Our Reference: 24706L#1

4<sup>th</sup> May, 2018

**The Village Alphington, Lot 2B 626 Heidelberg Road, Alphington - Proposed Mixed Use Development  
Traffic Engineering Review**

Figure 1: Parking Demand Profile

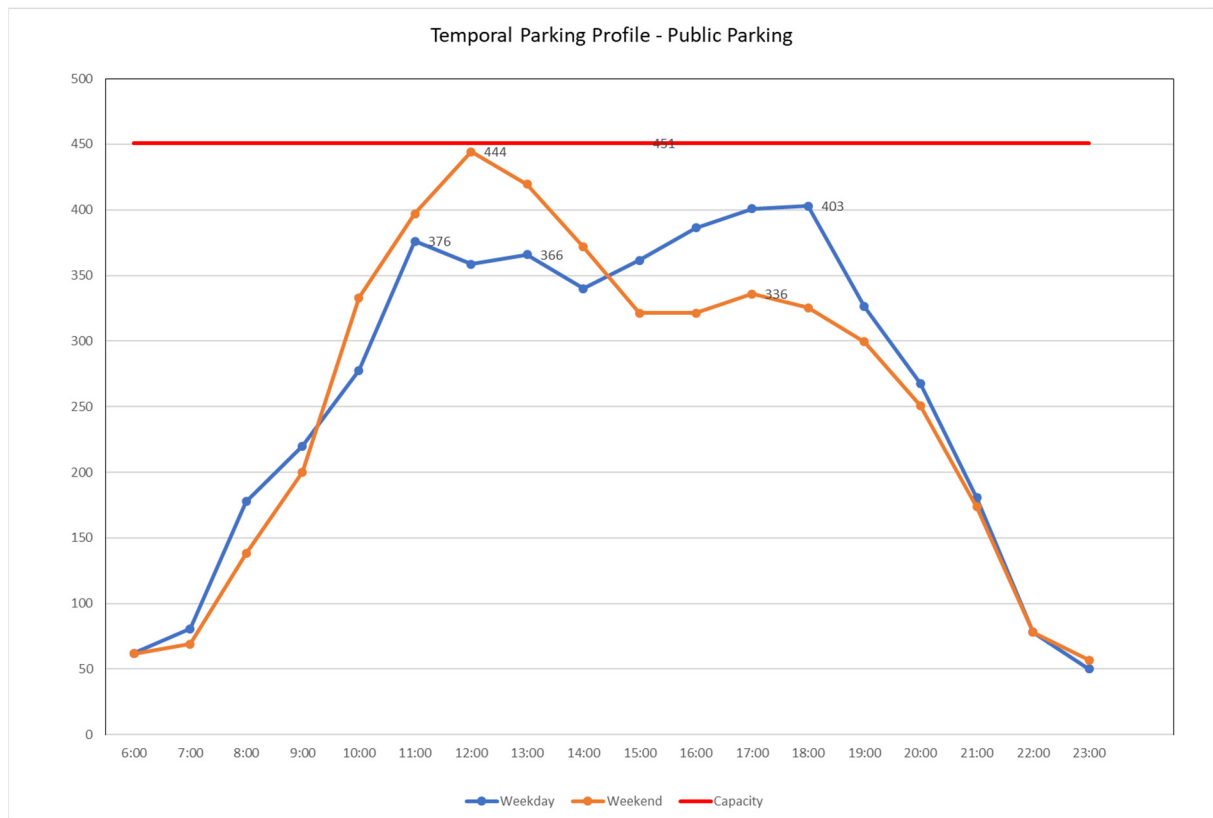
We have completed our own assessment of the variation in parking demand based on our experience and a review of the Google activity data for similar land uses in Fairfield, Ivanhoe and Alphington. The graph below summarises our assessment.

We are satisfied that this graph generally indicates capacity to accommodate the proposed uses – a conclusion generally consistent with the GTA assessment.

However, our graph does not include the community centre. We have been instructed to consider a community centre with up to 300 patrons as a 'worst case' scenario. We are satisfied that the

community centre can generally be accommodated on the site with up to 300 patrons (demand for 90 car spaces), with some notable exceptions.

Around Saturday at midday and in the early evening (5-6pm) on a weekday, there is limited capacity to accommodate large gatherings at the community centre. There are no issues with accommodating large gatherings during the evening on any day (after 6pm).

- Review whether more car parking is required for this use. A car parking rate of 0.3 car spaces per patron permitted is the appropriate rate to apply in this analysis.
- Review maximum patron numbers at the community centre during the day (only). There is no issue with 300 patrons at the centre after 6pm.

**Figure 2: Relocation of bicycle lane adjacent to traffic lane to avoid vehicles exiting Access Lane blocking the bicycle lane**

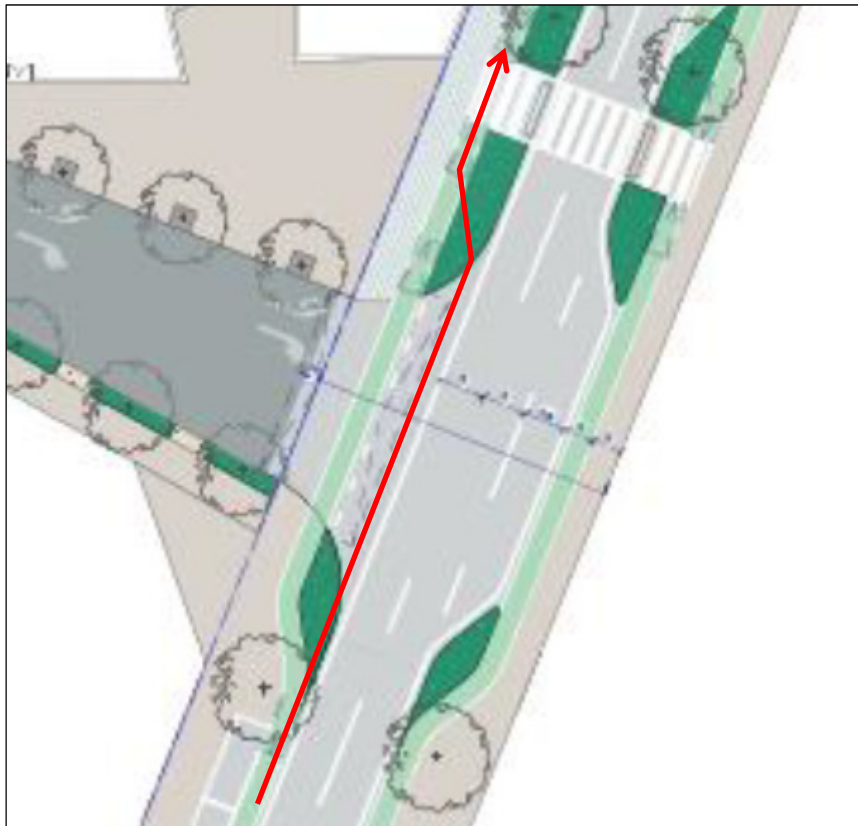
Figure 4.1 of the report provides a concept plan of the design Latrobe Avenue carriageway. We are generally supportive of the move to separated bicycle lanes. The one potential issue with the plan as proposed is that vehicles exiting the Access Lane will straddle the bicycle lane as they exit onto Latrobe Avenue. It is preferable that the bicycle lane is maintained directly adjacent to the traffic lanes past the Access Lane. This is shown in the following diagram. The appropriateness of either option should be reviewed by a Road Safety Audit of the design.
